# Change Notice

# FT Series

## Changes to Connectors on Touch Screen Controller Board

Changes for FT Controller Board  
FTCS05B Shown

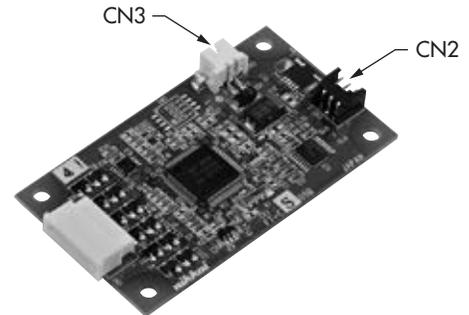
There will be revisions to the connectors for the FT Series Touch Screen controller board for RS232C. The changes will be for the header connectors for CN2 and CN3, and will effect standard part numbers (listed below) and custom part numbers.

Changes for Touch Screen Controller Board		
Part Number	Before Change	After Change
FTCS04A FTCS04A2	CN2: Hirose DF3Z-3P-2H(20) CN3: Hirose DF3Z-2P-2H(20)	CN2: <b>Hirose DF3E-3P-2H(20)</b> CN3: <b>Hirose DF3E-2P-2H(20)</b>
FTCS04B FTCS05B	CN3: Hirose DF3Z-2P-2H(20)	CN3: <b>Hirose DF3E-2P-2H(20)</b>
